Sydney Metro Northwest Places Program Hills Showground Station Precinct SSD 9653

Response to Submissions Report

Applicable to:	Hills Showground Station Precinct, Sydney Metro Northwest (SSD-9653)
Author:	Vas Cardassis
Owner	Sydney Metro
Status:	FINAL
Version:	06
Date of issue:	16 September 2020
Review date:	16 September 2020
© Sydney Metro 2019

Figure 3 Integration with Castle Hill Showground (Cox 2020)

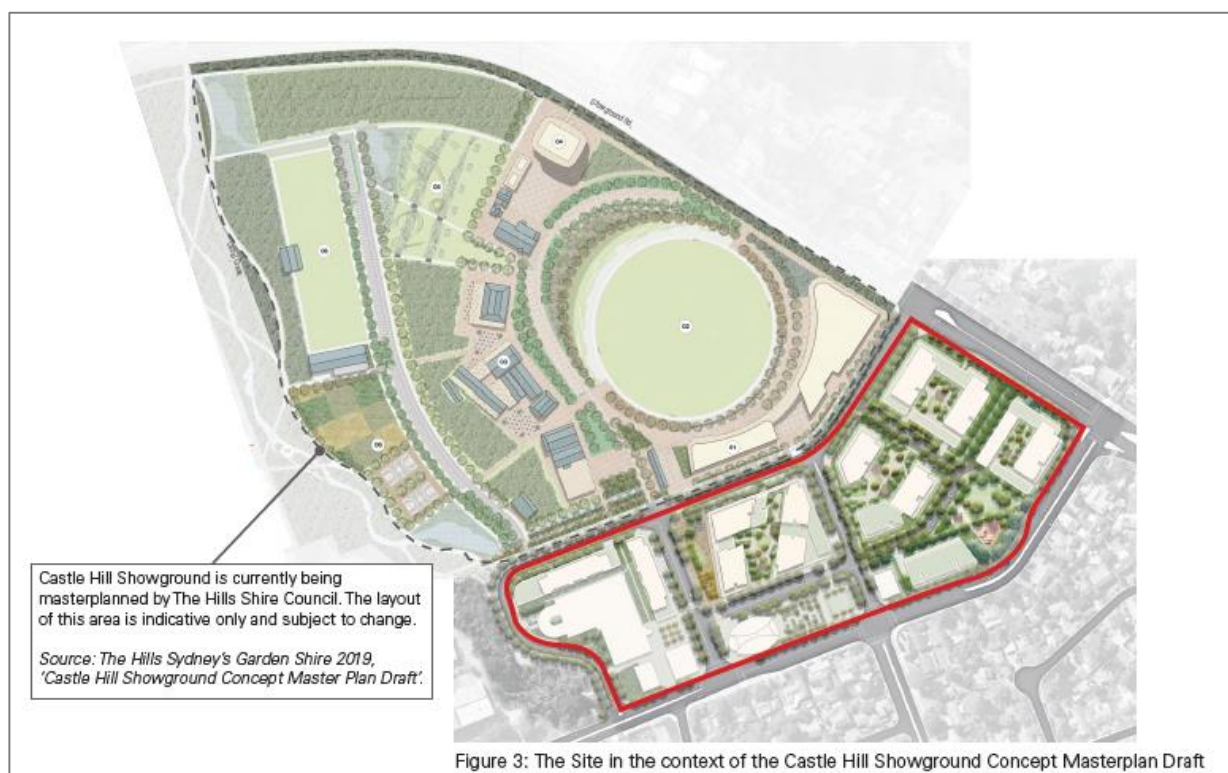
Issue/recommendation	Project response	Appendix Ref
<p>4. Integration with Castle Hill Showground</p> <p>Illustrate how the proposal integrates with Council's draft Master Plan for Castle Hill Showground.</p>	<p>The draft Master Plan for Castle Hill Showground was placed on exhibition following the exhibition of SSD 9653. However, the concept proposal and Master Plan were developed in collaboration and the subsequent revised plans for both now complement each other in terms of uses, street activation, podium scale, active transport and planned programming of public open space.</p> <p>The Urban Design Report includes an illustration on how the Concept Plan integrates with Council's draft Master Plan for Castle Hill Showground. The interface to the Showground and demonstration of clear access and linkages between the two master plans is illustrated in Figure 3. Physical movement connections between the regional recreation, events and leisure destination of the Castle Hill Showground and the Hills Showground Station Precinct are planned as follows:</p> <ul style="list-style-type: none"> • Doran Drive will be an activated spine, framed by retail and food and beverage uses • Andalusian Way will become a green street with ample street tree planting and a potential shared pedestrian and cycle path between the Castle Hill Showground and the planned shared path on Middleton Avenue south of Carrington Road (a Council led project) • Cattai Creek shared path is envisaged to be extended north through the Cattai Creek corridor adjoining the Castle Hill Showground (a Council led project) • Complementary uses are also being considered by Council for the Castle Hill Showground in food and beverage uses north of Doran Drive, sports community uses north of the Doran Drive and Showground Road intersection and a mixture of events, food and beverages, culture, entertainment, regional parklands, dog training and community uses within the Castle Hill Showground. <p>The Urban Design Guidelines gives further consideration to the following matters:</p> <ul style="list-style-type: none"> • identification of verge widths and relationship to future podium • provision of 3m setback and design controls to facilitate outdoor dining • pedestrian and cycle connectivity • public domain materials, finishes and landscape species for a cohesive approach between existing plazas and streets, this proposed development and the development of Castle Hill Showground • acoustic controls to ensure noise from the Showground and active street frontages are considered. 	<p>UDR Appendix H</p> <p>UDG Appendix I</p>

Figure 11 Revised Concept Plan (Cox, 2020)

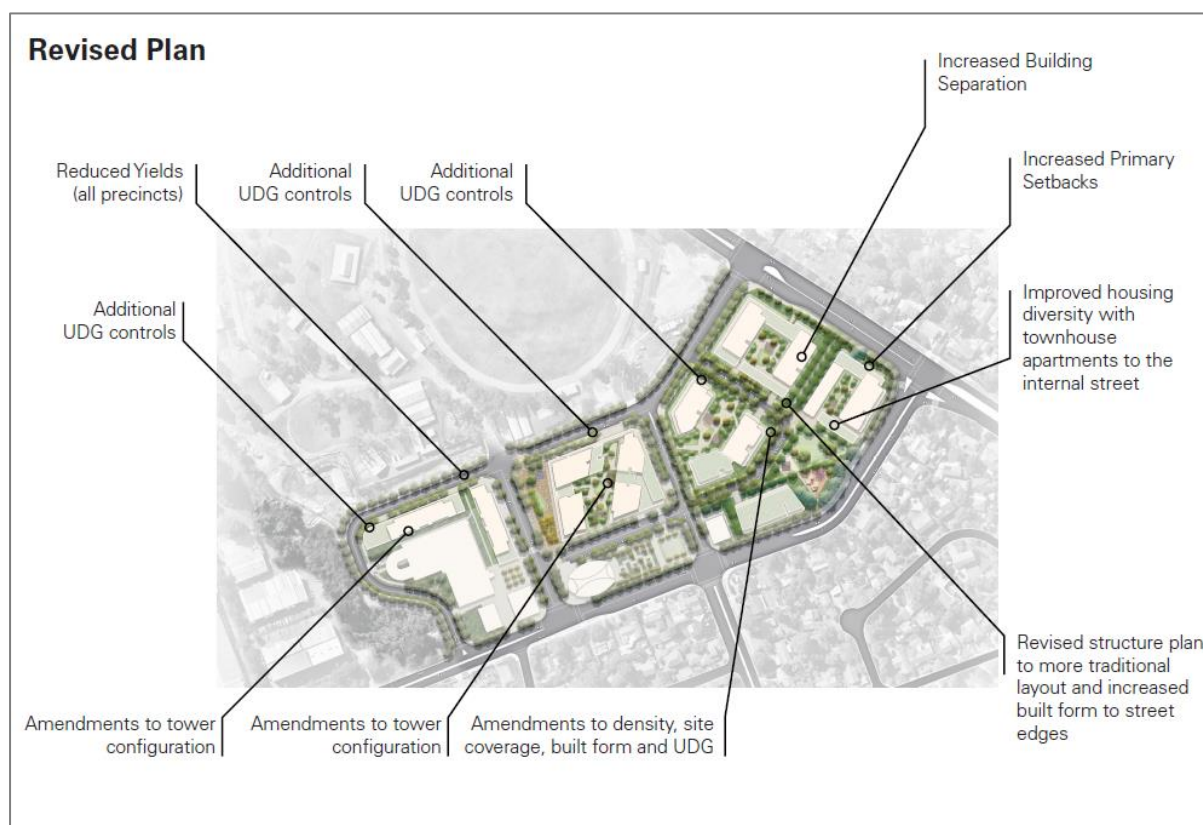
Table 14 provides a comparison between the key features of the concept proposal as exhibited and the revised plan. These changes are illustrated in **Figure 11**.
